# The M2 Noise Problem - An Engineering Perspective

Glynn Rogers  
Beecroft Cheltenham Civic Trust  
9/4/2024

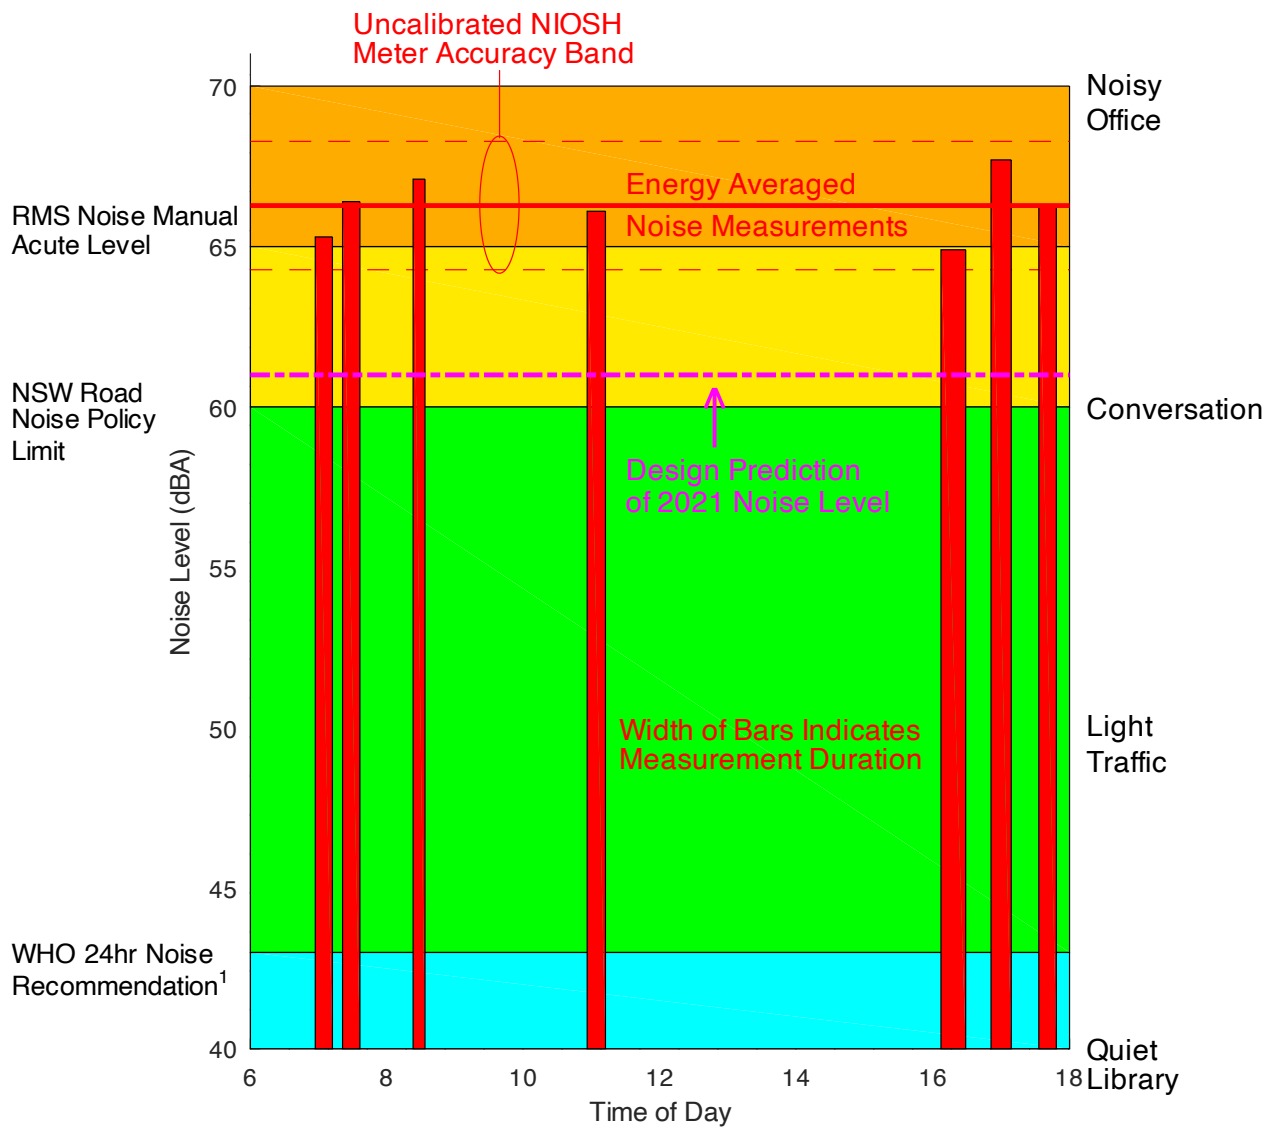
9. These measurements are presented as a bar graph in the accompanying Figure which also provides a graphical representation of the noise assessment context described above. The major features are the 'energy' average of the residents measurements and the 2021 model results. Clearly, the resident's measurements are much higher (5.3dBA) than the model's 2021 predicted noise levels.

10. The most plausible explanation for at least the major part of this difference is the increase in noise level because of deterioration of the original M2 road surface that is present in the current eastbound lanes. There is no indication that the modelling process took this into account.

25. These measurements are presented as a bar graph in the accompanying Figure which also provides a graphical representation of the noise assessment context described above. The major features are the 'energy' average of the residents measurements and the equivalent Future Design (2021) model results derived from Appendix E of M2 Upgrade – Part 1

Environmental Assessment Vol. 2 – Technical Papers, May 2010 (EA2). Clearly, the resident's measurements are much higher (5.3dBA) than the model's 2021 predicted noise levels.

- 26.** Indeed, the measured results would demand noise mitigation action by both of the criteria in Scenarios 1 and 2 because -
- a.** they exceed the NSW Road Noise Policy base criteria references in Scenario 1, and they exceed the 2dBA threshold of Scenario 1 and,

- b.** they are above the Scenario 2 acute threshold as defined in the Roads and Maritime Services Environmental Noise Management Manual.
- 27.** This *major difference between the measured and predicted results* invites explanation. There appear to be four possibilities.

11. If this explanation is correct than it seems clear that the Trust's activities would be best directed towards requesting Transport for NSW to require Transurban to resurface the M2 between Beecroft and Pennant Hills Roads using an effective low noise road surface.
